# United States Patent and Trademark Office

APPLICATION NO.	FILING DATE	FIRST NAMED INVENTOR	ATTORNEY DOCKET NO.	CONFIRMATION NO.	
10/698,158	10/31/2003	Jeffrey D. Carnevali	NPI-019	9849	
7	590 09/07/2006		EXAMINER		
Charles J. Ruj PO Box 46752		STERLING, AMY JO			
Seattle, WA			ART UNIT	PAPER NUMBER	
·			3632		
			DATE MAILED: 09/07/2006

This is a non-final Office Action for application number 10/698,158 Flexible Support Arm, filed on 10/31/03. Claims 1-3, 5-21 are pending. The text of those sections of Title 35, U.S. Code not included in this action can be found in a prior Office action.

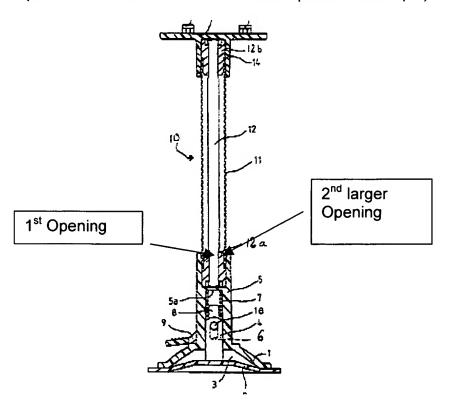
Richter teaches the basic inventive including teaching a flexible support apparatus (10) having a support base (10) having an opening in one surface and a mounting bracket having an opening (13) in one surface and a permanently bendable continuously solid metal rod of substantially constant cross section, the rod being made of aluminum (12, See Col. 3 line 9 for rod material) having a first end installed in the opening of the support base and fused direction to the support base and having a

second end installed in the opening of the mounting means and fused directly to the mounting bracket and wherein the opening in the support base and mounting bracket have a second larger opening (Inner and outer openings, See Drawing Below) into which a flexible sheath (11) if inserted. Richter teaches the method forming a support base, forming a mounting bracket and fusing a length of the rod to the tubular apertures of the base and the bracket, a flexible plastic sheath (11) disposed around the metal rod (12) between the support base and the mounting bracket and wherein the bracket and the base both have a respective counter-bore which is substantially concentric with the respective tubular aperture and sized to admit the flexible plastic sheath (11).

This is unpersuasive because it is evident from the rejection above that the sheath fits into the second larger opening of the mounting bracket.
